A regular meeting of the Troy Planning Commission was held in Council Chambers, City Hall, Wednesday, September 18, 2024, at 3:30 p.m. with Vice-Chairman Larry Wolke presiding as Chairman McGarry (who was present) was not feeling well. ATTENDING: Members – McGarry, Westmeyer, Wolke, Oda, Ehrlich, Emerick and Titterington; Development Staff – A. Eidemiller, and Development Director Davis.

HISTORIC DISTRICT APPLICATION - CERTIFICATE OF APPROPRIATENESS FOR 112-118 W. MAIN STREET FOR EXTERIOR MODIFICATIONS: WINDOW REPLACEMENTS, TWO NEW THIRD FLOOR WINDOWS INSTALLED ON THE WEST ELEVATION, AND PAINTING OF THE REAR AND SIDE FACADES; OWNER: TROY HISTORIC PRESERVATION ALLIANCE (THPA); APPLICANT: THPA BY BEN SUTHERLY. Staff reported: “ Applicant Ben Sutherly, on behalf of the owner, Troy Historic Preservation Alliance, has requested the Planning Commission to review window replacements, two (2) new window installations, and paint at the property located at 112-118 W. Main Street. This request will be for the second and third floor windows. The property is located in the B-3 Central Business District.

Front Façade: Previous

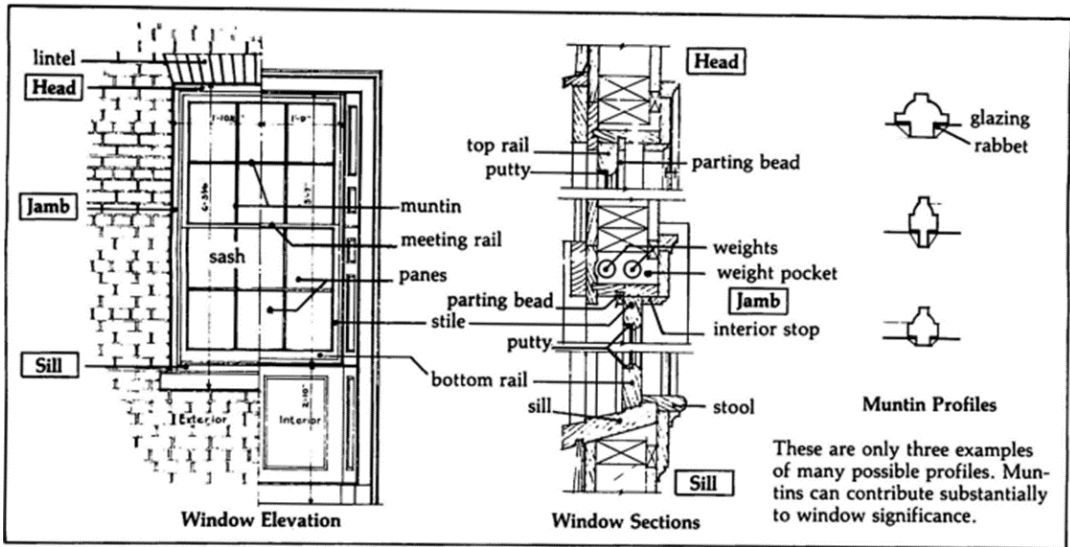
The 1902 portion of the building (three-story portion) includes twenty (20) windows with significant features in the arches, panes, and material. The third story on the front façade has four (4) prominent arched windows with two (2) smaller accent arches. Nine (9) over six (6) divided lights are present in the main arched window. The accent arches are one (1) over one (1) double hung windows. The second-floor windows are one (1) over one (1) double hung windows with accent double hung windows in between. The dynamic size of the second-floor windows makes these windows significant in comparison to the third-floor arched windows. The Applicant explained that due to the wave of the glass, it is likely that the windows are extremely old or original. A door opening is present on the fire escape on the south side of the 1902 building. The following pictures are from previous dates due to the windows being currently boarded up:

Window Replacements: The applicant is proposing the replacement of all the second and third floor windows on the 1902 building with Pella reserve Wood Windows wrapped in black aluminum. The number of muntins will match the original windows. On the 1840 building, the applicant is proposing six (6) over six (6) pane window replacements with the Pella Reserve Wood windows wrapped in black aluminum. A total of nine (9) windows are proposed for replacement on the 1840 building and twenty (20) on the 1902 building.

REPLACEMENT OF 29 WINDOWS. The staff report stated that staff is unable to recommend approval on the window replacements based upon Design Manual Section 2.8 B: Clear evidence was not supplied by the applicant that illustrates extensive deterioration is present on the second and third floor windows on the front and rear facades. Additionally, clear evidence was not provided that the windows cannot be repaired, even at significant cost.

Development Director Davis noted that the Commission members had received supplemental information from the application (copy attached to original minutes) and that information included pictures showing the bad state of repair of the windows. Mr. Davis indicated that information had been reviewed by staff and, based on that information, staff would now recommend approval of the replacement of the 29 windows. Mr. Davis asked THPA representatives to comment. Pella company representatives provided a sample of the windows proposed to be used for the replacement of the second and third floor windows. Mr. Davis stated that 29 windows would be replaced, 9 on the 1840 building portion and 20 on the 1902 building portion.

Commission Recommendation on Replacement of 29 Windows: A motion was made by Mr. Titterington, seconded by Mrs. Ehrich, that based on the supplement information from the application and the amended recommendation of staff to approve the window replacement as meeting the guidelines, that the Troy Planning Commission approves the Historic District Application - Certificate of Appropriateness for the replacement of 29 windows for 112-118 W. Main Street.
